Strategic Sites Committee agenda

Agenda Item	Page No
1 Apologies for absence	
2 Minutes To agree the minutes of the Strategic Sites Committee meeting held on 16 March 2023.	3 - 6
3 Declarations of interest	
4 22/03783/APP - South East Aylesbury Link Road (Phase 2) Improvement Scheme	7 - 134

Proposal: South East Aylesbury Link Road (Phase 2) improvement scheme including dual carriageway (for the Stoke Mandeville Relief Road and to provide connection with the South West Aylesbury Link Road), new roundabout, lighting columns, maintenance bays and access points, diverted public right of way, uncontrolled crossing, provision of two shared cycle/footways, noise bunds and barriers, relocated field accesses, grass verges, road restraint systems, mammal tunnel, flood compensation storage areas, woodland planting, landscaping, habitat creation, drainage ponds and swales, substation and associated infrastructure and earthworks.

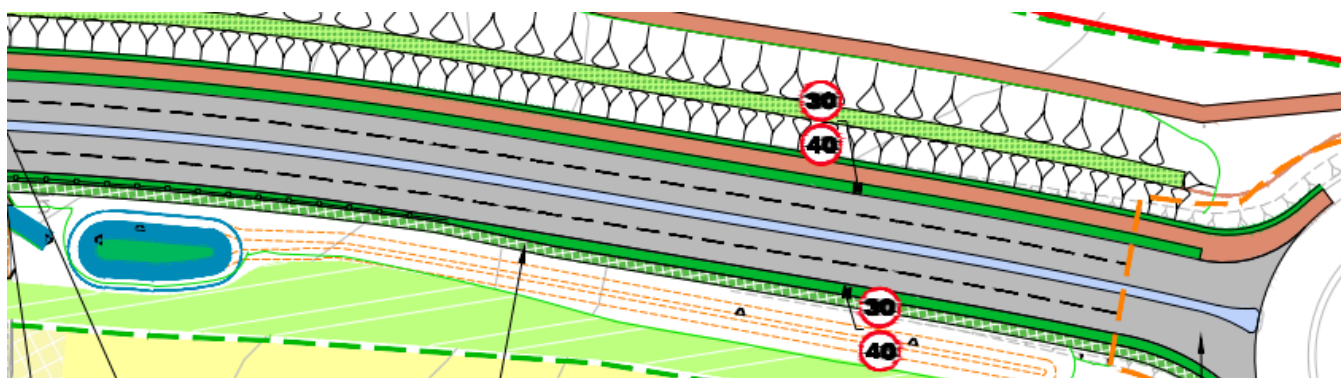
Swept path analysis drawings have been provided of the western SEALR Phase 2 / SWALR/ SMRR Roundabout and demonstrate that an articulated HGV can stay in its lane on the roundabouts, with the exception of the gated field access on the western roundabout where the vehicle is required to use both running lanes to access and egress the field access. An exert is shown below.

Although this was not raised in the September 2022 review of the Road Safety Audit, BC is concerned that this layout would result in collisions on the roundabout. BC require the applicant to relax the radius

of the field access, in line with the original design, which would allow large vehicles to access and egress the site using one running lane only.

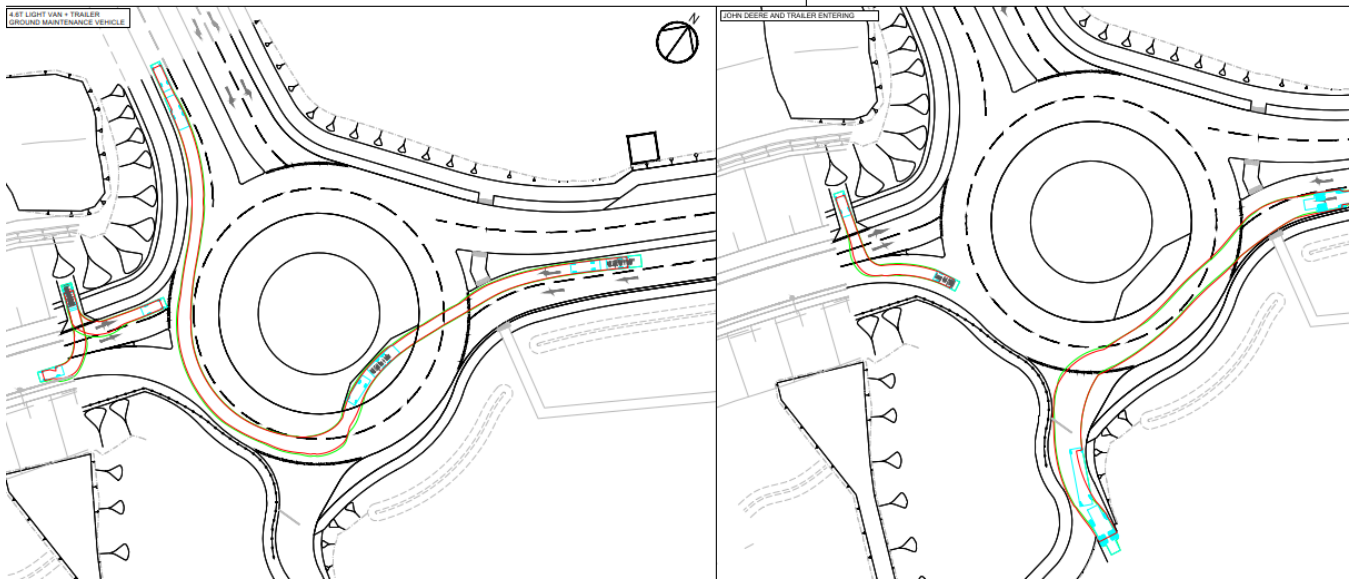
“A 2m wide maintenance track (the purpose and likely usage of which is unclear) is proposed adjacent and parallel to the westbound phase 2 link carriageway, segregated only by a narrow verge. If this track is to be used by vehicles, there are the following risks:

- *Westbound drivers on the link road may be distracted/ confused by the presence of vehicles on their nearside on the track, particularly if they have headlights on for example;*
- *There may be inadequate clearance between track users and vehicles in the westbound nearside lane of the SEALR; and*
- *Lighting columns are positioned within the maintenance track which may result in vehicles encroaching into the link road to bypass them; and*
- *Part of the track sits behind the proposed ‘indicative vehicle restraint system’ midway along the link. Track users will therefore not be protected from the water hazards in this area and it is unclear whether they will have adequate working width behind the barrier and between the water hazards. Users may be at risk of injury should a vehicle collide with the barrier or should their vehicle enter the water.*

The above concerns could result in unsafe conditions for road users on the link road and the maintenance track.”

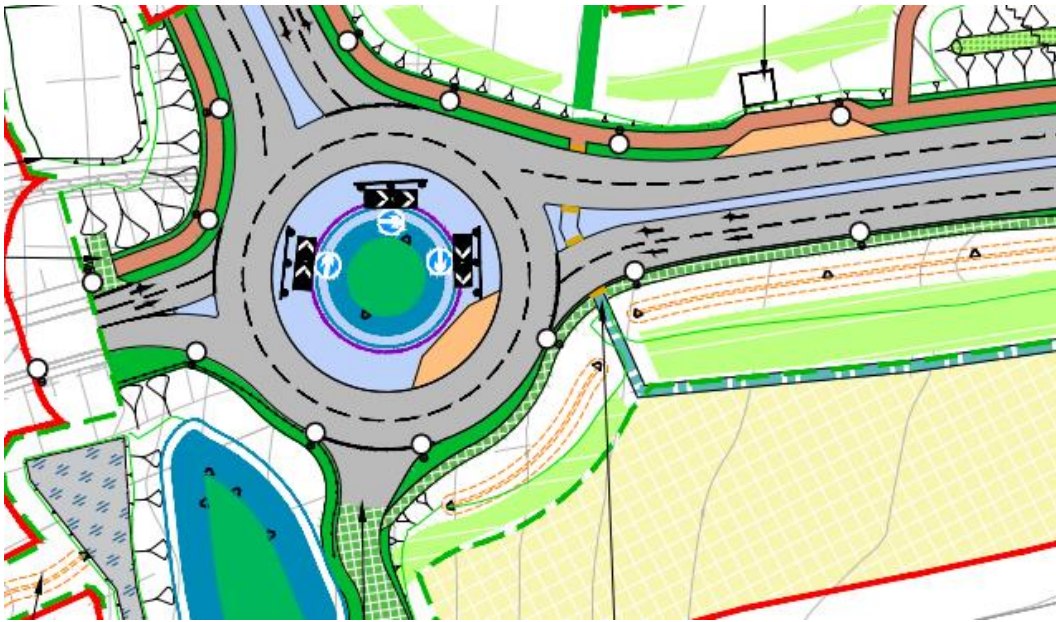
“The location of the HS2 maintenance access close to the roundabout is of concern, i.e. in terms of the impact it would have on the roundabout (gap seeking right turners waiting on the exit arm to turn right into the access being struck by other vehicles exiting the roundabout or rear end shunts on the western arm approach as following drivers are unlikely to expect vehicles to be slowing/ turning immediately upstream of the access).”

However, if the movements are infrequent, and undertaken by the types of vehicles as understood in communications from the design team, namely “the design vehicle being a 4x4 vehicle. Use of the access will be infrequent and will only be used for embankment maintenance and grass cutting” then this is not expected to constitute a significant road safety issue. Although it is acknowledged that 4x4 vehicles are smaller than the agricultural vehicles which were shown turning in/ out of the access in the initial swept path layouts audited, the design team should ensure that these vehicles are still able to turn in/ out of the access safely/ without slowing too significantly on the approach

It is recommended that the access is relocated further west on this arm of the roundabout and that wider radii is used to ensure traffic accessing/ exiting the access is able to do so without encroaching on the opposing traffic lane.”
